**TO:** District of Columbia Zoning Commission

**FROM:** *JLS*  
Jennifer Steingasser, Deputy Director- Development Review & Historic Preservation

**DATE:** March 25, 2019

**SUBJECT:** ZC 06-10 D Final Report for Updated 2<sup>nd</sup> Stage Application for an Approved Consolidated and Preliminary Planned Unit Development and Map Amendment for proposed “Art Place and Shops at Fort Totten”; Modification of Approved First Stage Order, as it Pertains to Building B of Second Stage

Figure 1. Currently Proposed Building B Site Plan (in center)

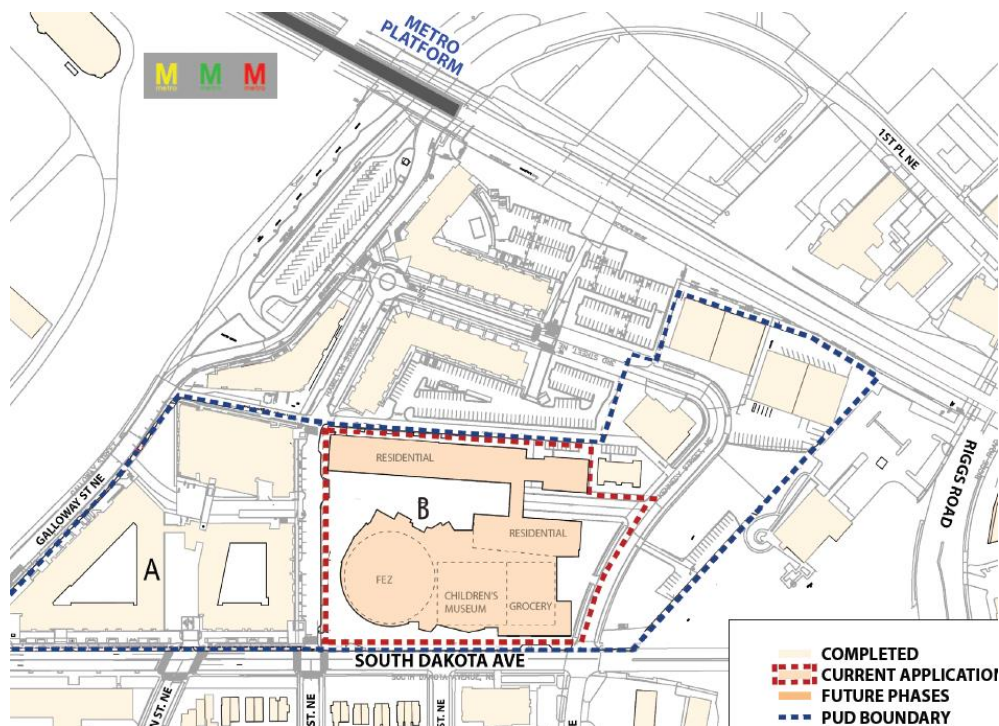
The proposal has changed and evolved since setdown. The proposed Building B would, in portions, be 20 feet taller than what was approved at Stage 1 and 5 feet taller than was set down for this case. It would also be 0.43 FAR denser than its Stage 1 approval, which is 0.21 FAR greater than was set down for this case. The applicant has not requested a change for the overall FAR of all four stages of the PUD. The changes are an improvement from the setdown but the application requires refinements, and additional information if the PUD is to realize its potential to become an uptown urban center of significance to the neighborhood, the District and the region.
